ARCHITECTURAL REVIEW BOARD STAFF REPORT

Project #/Name	SP-2023-19: Stonefield Tesla Outdoor Sales, Storage and Display
Review Type	Advisory Review for a Special Use Permit
Parcel Identification	061W00300019A0
Location	Four parking spaces along the northeast elevation of the building at 1951 Swanson Dr. and six parking spaces along the southeast elevation of the building at 1954 Swanson Dr. (See Fig. 1 and Attach. 1.)
Zoned	Neighborhood Model District (NMD), Entrance Corridor (EC)
Owner/Applicant	OCT Stonefield Property Owner LLC/Woods Rogers Vandeventer Black (Steve Blaine)
Magisterial District	Jack Jouett
Proposal	To establish outdoor sales, storage and display of vehicles associated with a Tesla vehicle sales office. (See Attach. 2.)
Context	The immediate context is the Stonefield Town Center.
Visibility	The parking spaces proposed for sales, storage and display are existing spaces in existing parking lots. They are visible from the Entrance Corridors but aren't readily distinguishable from nearby parking spaces. (See Figs. 2 and 3.)

ARB Meeting Date	January 16, 2024
Staff Contact	Margaret Maliszewski

Fig. 1: Left: Location of proposed outdoor sales, storage and display parking spaces within the Stonefield Town Center. Right: Proposed Tesla parking plan.

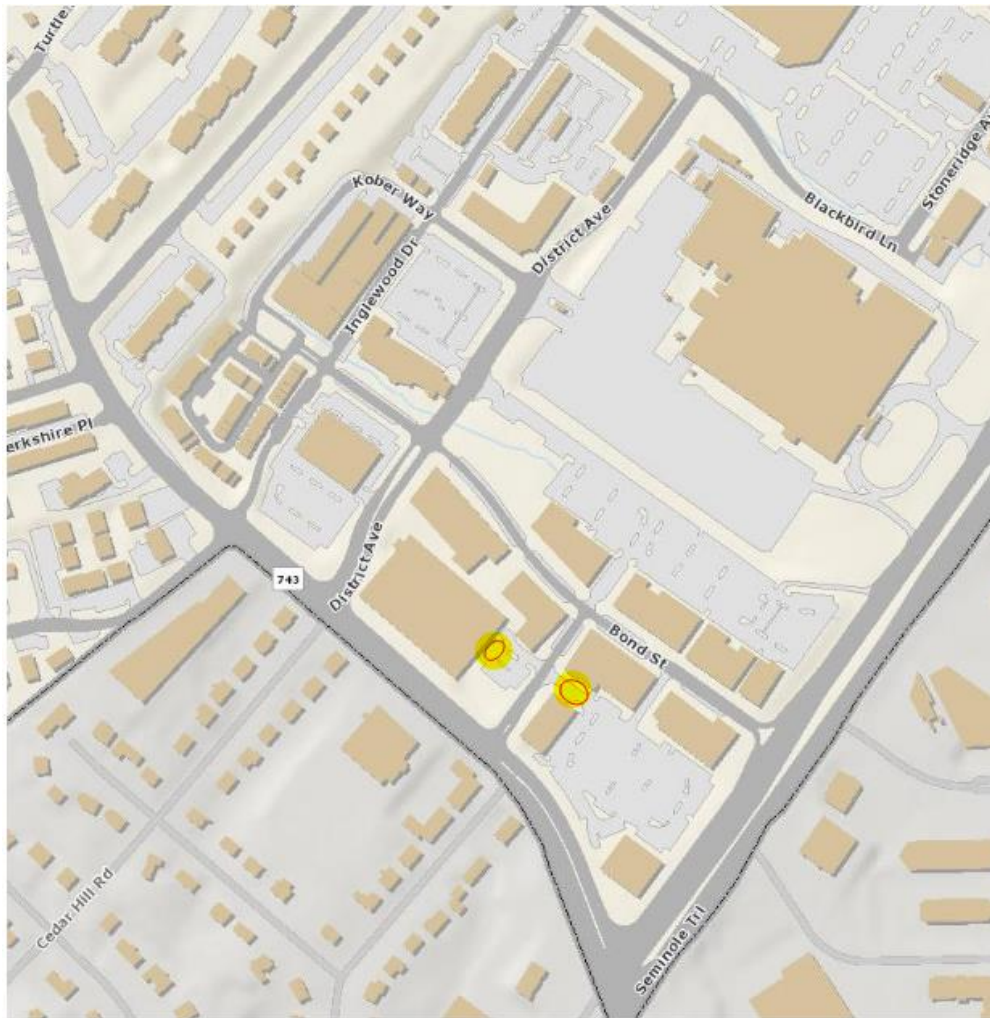
1. Visual impact of proposed outdoor sales, storage and display parking on the EC streets.

1. Use of this site must be in general accord with the Tesla Parking Plan. To be in general accord, vehicles for sales, storage and/or display must be parked only in the spaces indicated for sales, storage and display on the Tesla Parking Plan.
2. Vehicles for sales, storage and/or display must be parked in striped parking spaces.
3. Vehicles must not be elevated anywhere on site.
